ADDENDUM NO. 3
CITY OF FOLSOM
Water Treatment Plant Backwash and Recycled Water Capacity Project

ISSUED BY
THE CITY OF FOLSOM
ENVIRONMENTAL AND WATER RESOURCES DEPARTMENT

This addendum shall be considered part of the Project Manual for the City of Folsom Water Treatment Plant Backwash and Recycled Water Capacity Project.

**GENERAL
SITE PLAN AND SEQUENCING NOTES**

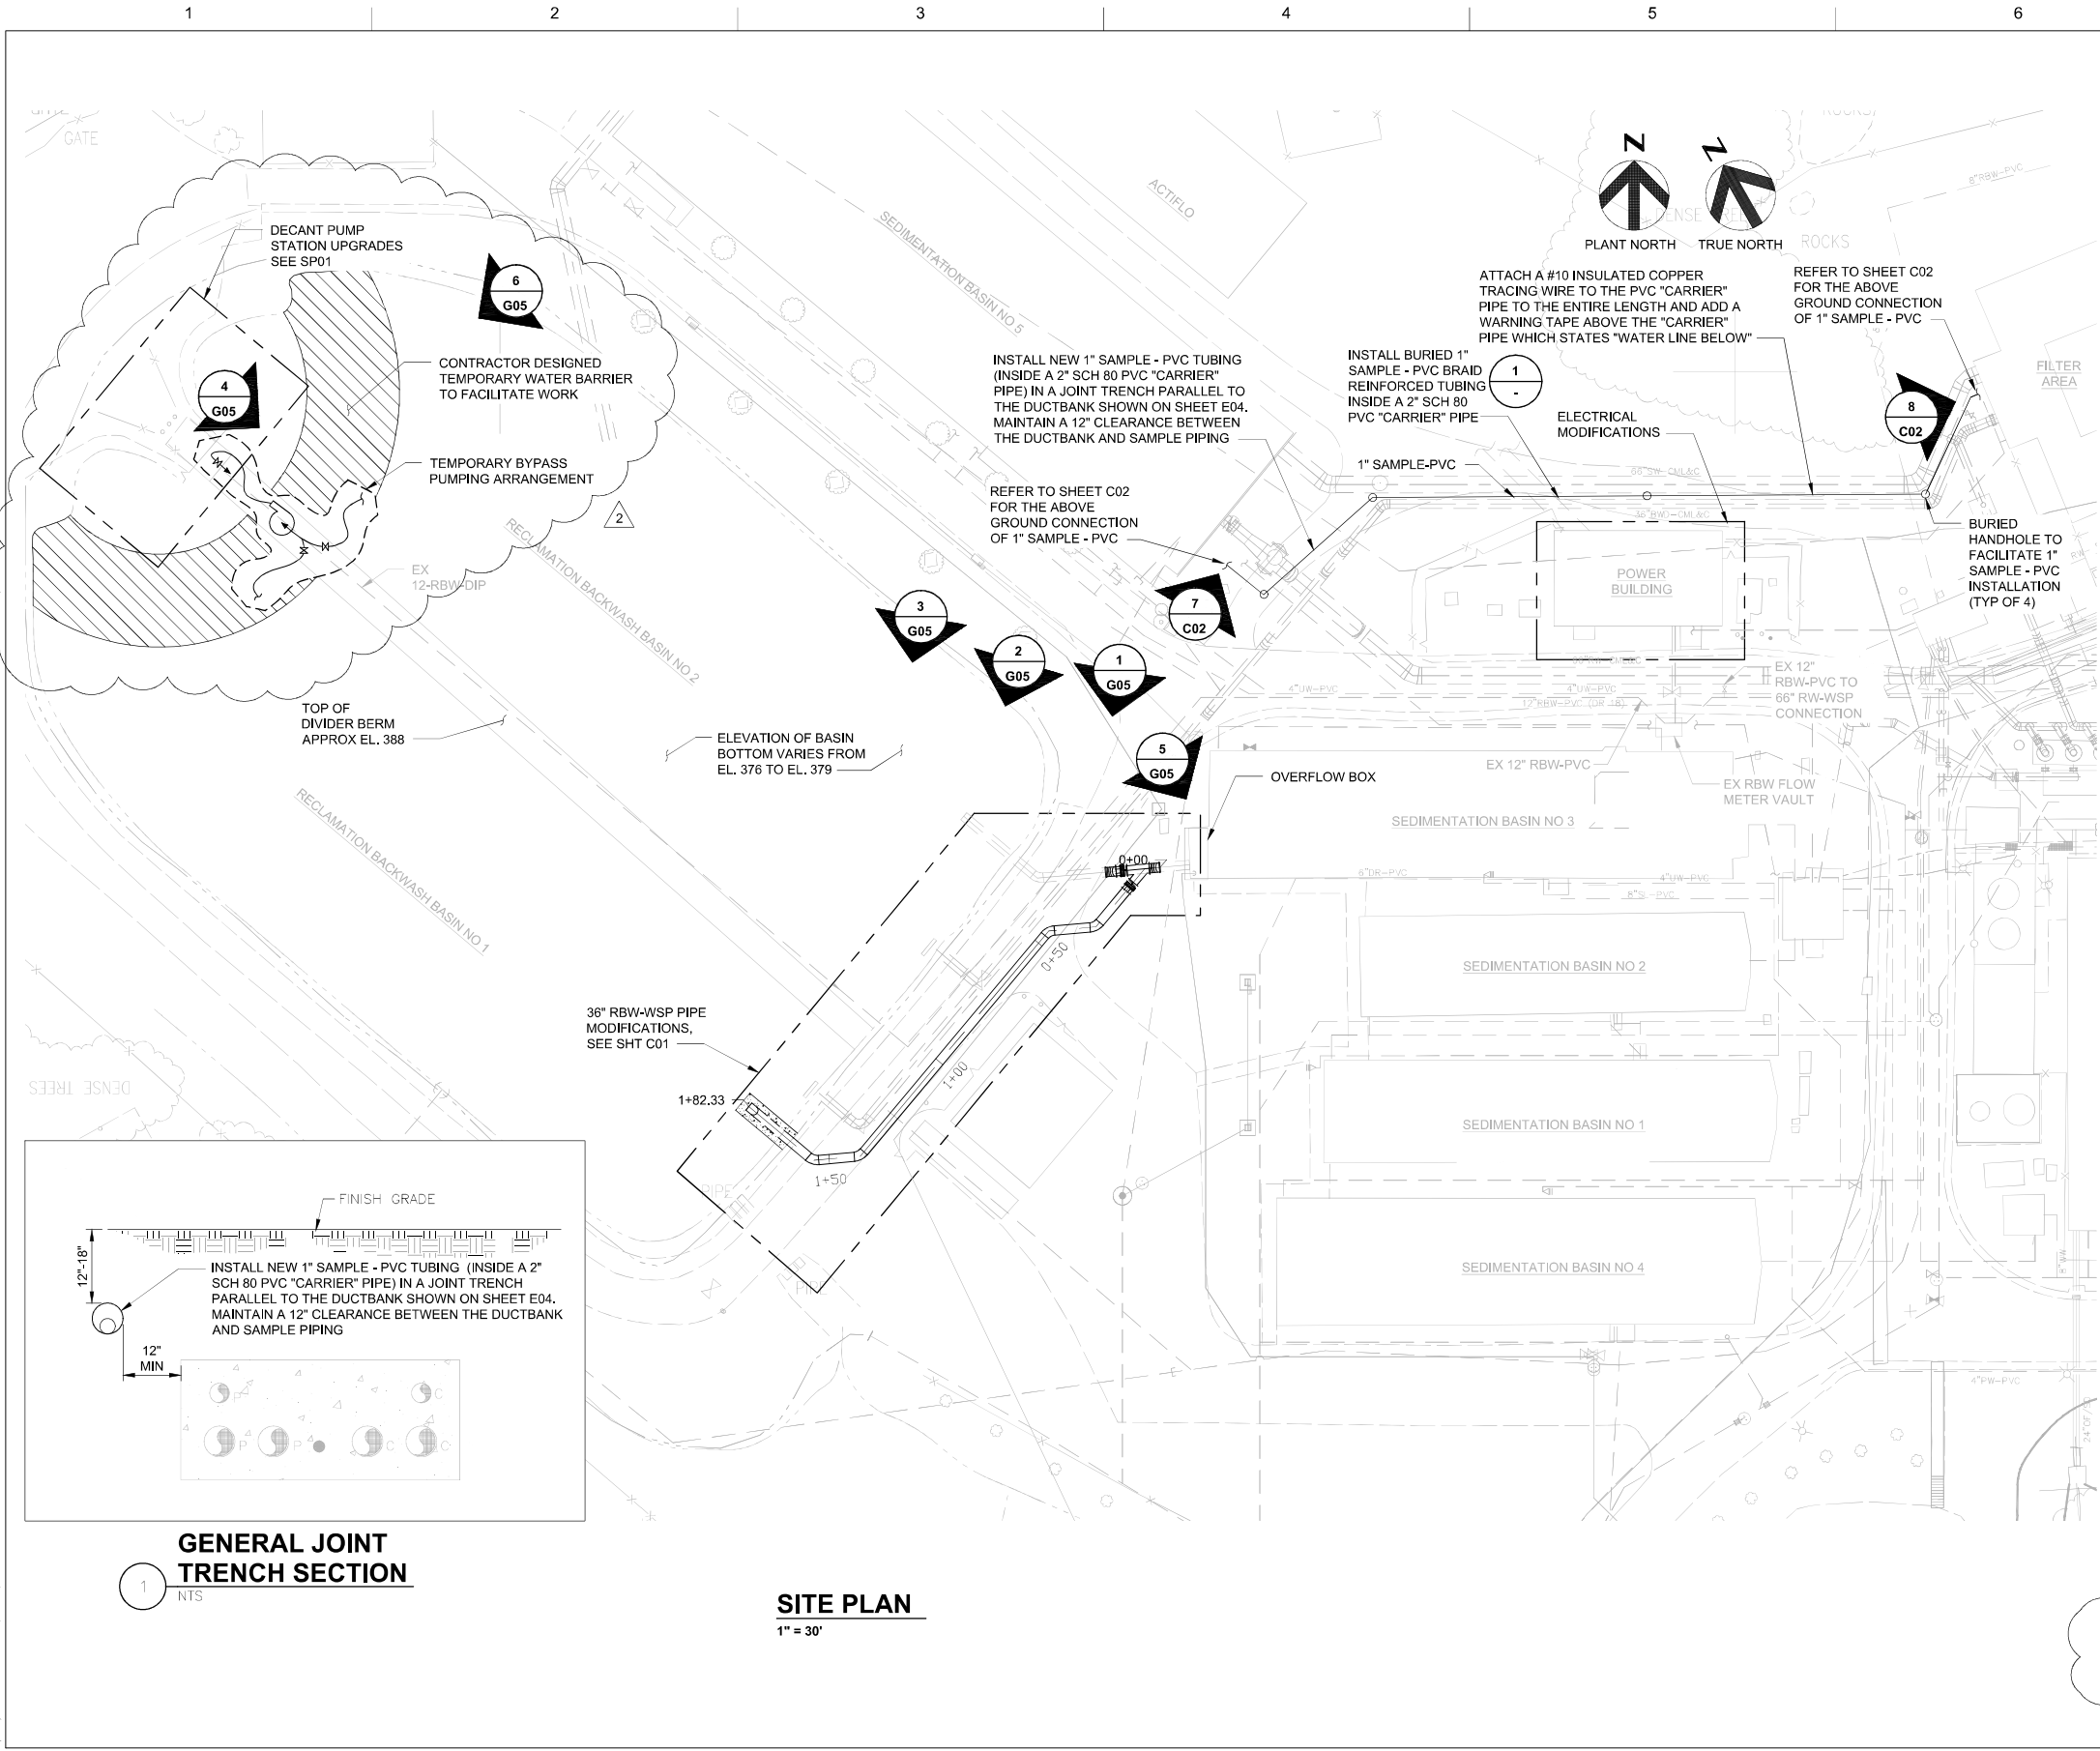
Question 6: *Drawing G04; Temporary bypass piping referenced in Phase I (VII) and Phase 2 (II) will be connecting to the existing 12" RBW line. Please confirm.*

Question 9: *Drawing G04; Phase I (Item V), once the decant pumps draw down the maximum amount of water they can pump, how much water will be remaining in the basin (depth of water), for minor dewatering?*

Question 10: *Drawing G 04; Phase I (item V-A), how much 'sludge' should the Contractor expect (in volume) to be removed from each basin? Please identify by a drawing, showing the location of the sludge drying bed where the sludge will be disposed of.*

Question 13: On Drawing Sheet G04, Sequencing Notes, Phase 1, Item V. A., states the sludge in the bottom of the basins shall be pumped out to onsite sludge drying bed in order to completely clean the area surrounding the Decant PS to facilitate work.

- a. Can you clarify the exact area, depth, and volume of sludge to be removed?***
- b. The sludge underneath the cofferdam footprint will need to be removed prior to installing the cofferdam in order to get a good seal. This will be a lot of work to accomplish in a 24-hour shutdown. Can we do the cofferdam in one basin in one 24-hr shutdown, then the other basin in a separate 24-hr shutdown?***
- c. Can you clarify exactly where the drying bed is where the sludge will be placed?***
- d. Please confirm the City will drain the basins prior to sludge removal and cofferdam installations.***

Question 17: *In regard to this project per Plans page G04, under General Notes, section ii, part D requires the use of NSF-61 certified pumps for the temporary bypass. Only permanently installed pump options exist with the NSF-61 certification capable of handling the projects flow requirements. Temporary bypass pumps that meet this specification are very limited. Can the specification be revised to include additional pump options?*

Response: Temporary bypass piping referenced on the plans will connect to the existing 12" RBW line as shown on the project drawings.

Response: Based on the best available information, it is assumed there will be approximately three (3) feet of water depth remaining in the basin and decant pump station.

Response: There is approximately 22 inches of sludge at the northern end of the basin near the pump station and 10 inches of sludge at the southern end of the basin near the proposed 36" pipeline work. The intent for sludge removal is to relocate the sludge from the area of

Response: Only NSF-61 pumps that are for use in clean-water applications are allowed for work within the Water Treatment Plant and as part of this project.

ENLARGED PLAN OF 36" RBW-WSP PIPELINE
1" = 10'

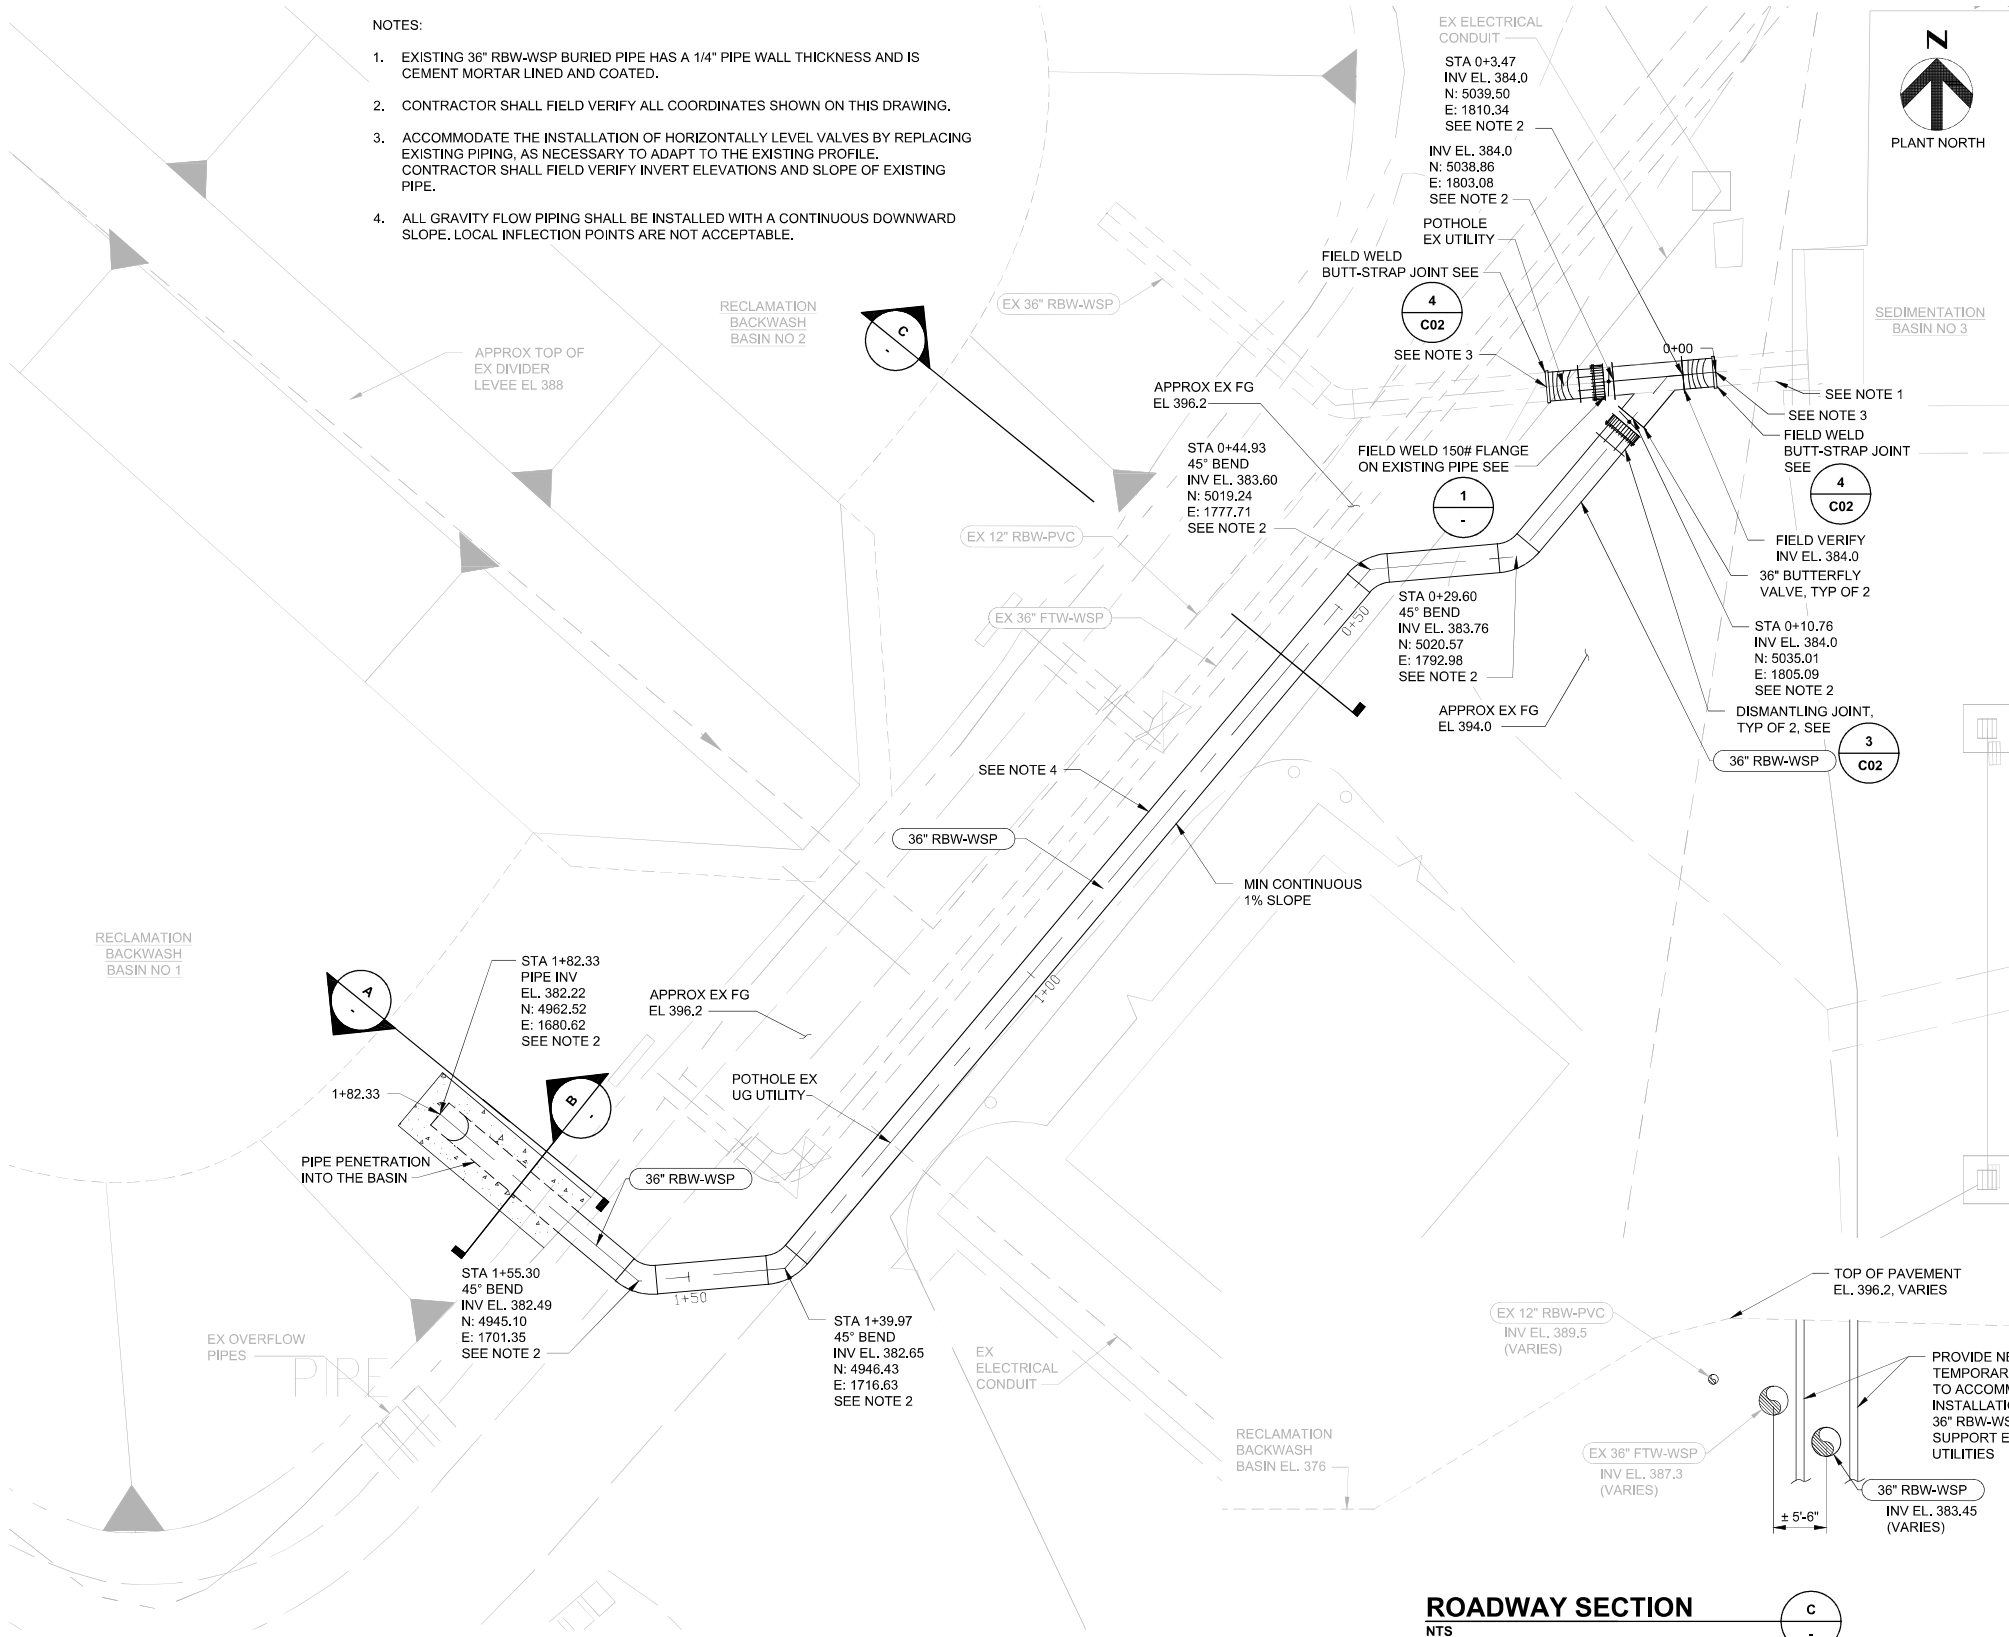
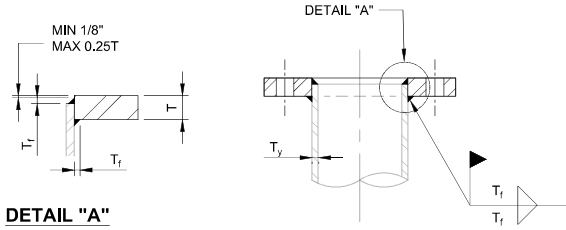
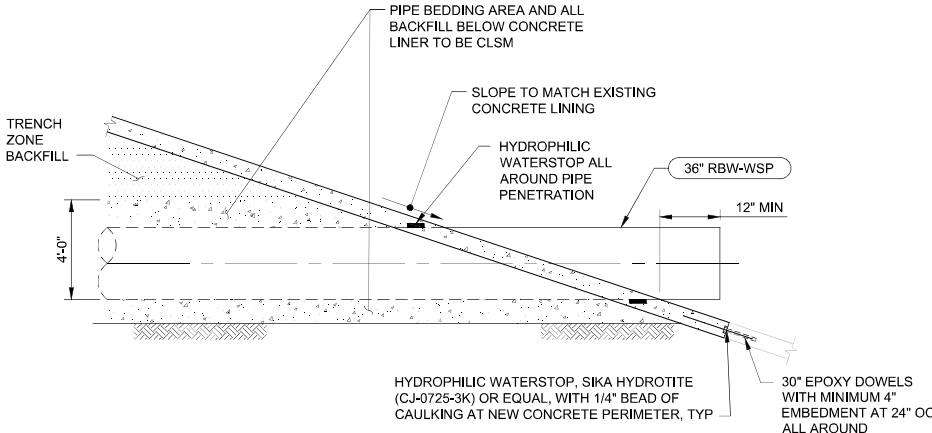
Question 16: *Drawing Sheet C01, Note near middle of page states, "FIELD WELD 150# FLANGE ON EXISTING PIPE" and Detail 1, these do not appear to apply since this is within the new section of pipe. Please clarify.*

Response: On sheet C01, grid C-4, modify callout "FIELD WELD 150# FLANGE ON EXISTING PIPE" to "FLANGED CONNECTION TO ACCOMMODATE DISMANTLING JOINT, TYP OF 2" and delete detail 1 symbology. The flange in question, which is also shown in detail 3 for the dismantling joint, may be factory installed.
